BCAC Meeting 5 proposals

10-13-2020 report

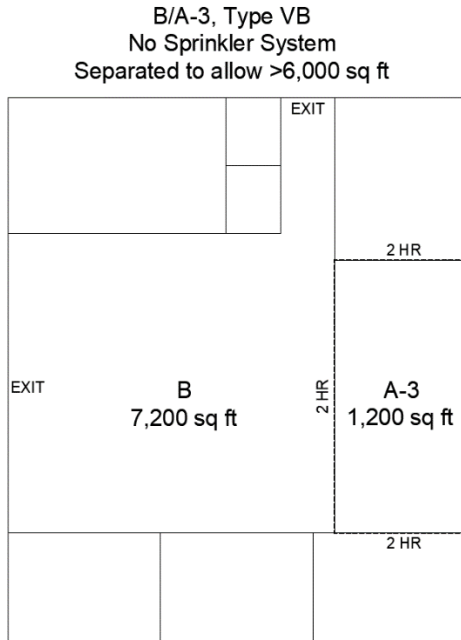
construction, in order to be larger than the 6,000 square feet restriction where the non-separated option is used, the separated option requires a 2hr fire barrier between the B and A-3. Looking at the illustration below the question is, what does the fire barrier achieve? Are we protecting the occupants in the A-3 that are going to exit out through the B? Are we concerned about the storage of combustibles that wouldn't actually occur in the A-3? How is the expense of the fire barrier in terms of materials, extra construction and design time to address all details therefore, and the cost to install and maintain all opening protectives justified in order to allow the allowable area to be ratio based, which logically should apply without any arbitrary separation? It makes sense to not penalize the building and code user.

510.2 Horizontal building separation allowance. A building shall be considered as separate and distinct buildings for the purpose of determining area limitations, continuity of firewalls, limitation of number of stories and type of construction where all of the following conditions are met:

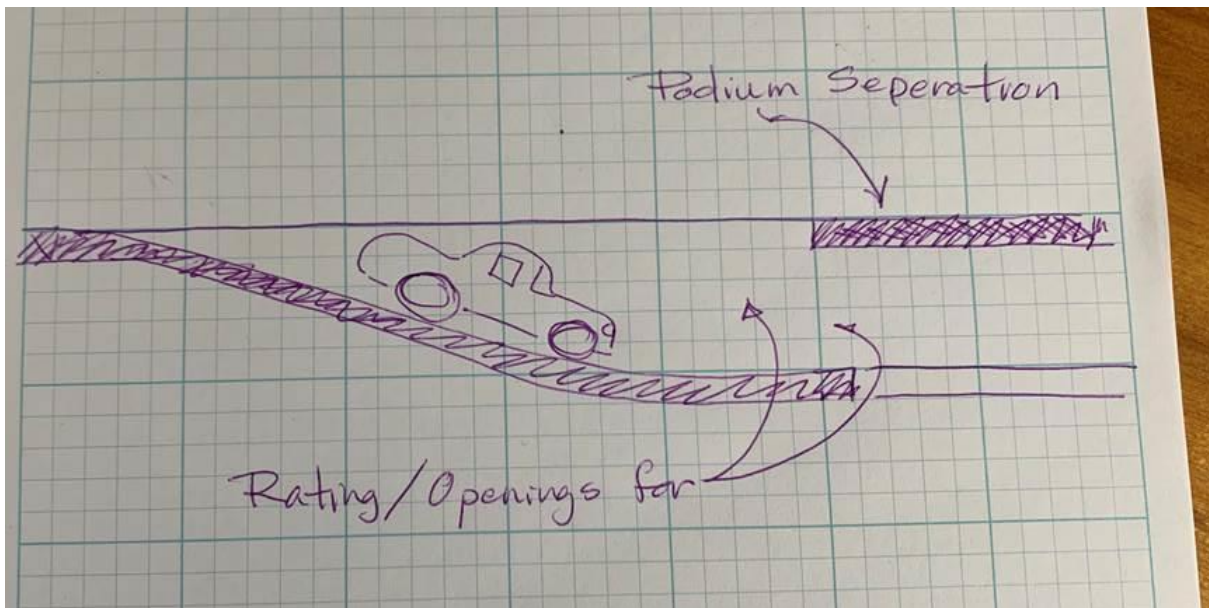
Reason: The code provides for the allowance of vertical offsets in horizontal building separations, but does not clarify how the separation must be constructed other than to also be 3-hour rated. This code proposal fills in the gap so that users know what type of assembly must be used, fire barriers, and subsequently how to address openings, penetrations, joints, continuity, etc. This also clarifies that the vertical offset must also be Type 1A construction just like the horizontal assembly does.

1. The buildings are separated with a horizontal assembly having a fire-resistance rating of not less than 3 hours. Where ~~vertical offsets are provided as part of the horizontal assembly~~ contains vertical offsets, the vertical offset ~~and the structure supporting the vertical offset~~ shall be constructed as a fire barrier in accordance with Section 707 and shall have a fire-resistance rating of not less than 3 hours.
2. The building below, including the horizontal assembly and any associated vertical offsets, is of Type IA construction.
3. Shaft, stairway, ramp and escalator enclosures through the horizontal assembly shall have not less than a 2-hour fire-resistance rating with opening protectives in accordance with Section 716.

Exception: Where the enclosure walls below the horizontal assembly have not less than a 3-hour fire-resistance rating with opening protectives in accordance with opening protectives in accordance with Section 716, the enclosure walls extending above the horizontal assembly shall be permitted to have a 1-hour fire-resistance rating, provided:
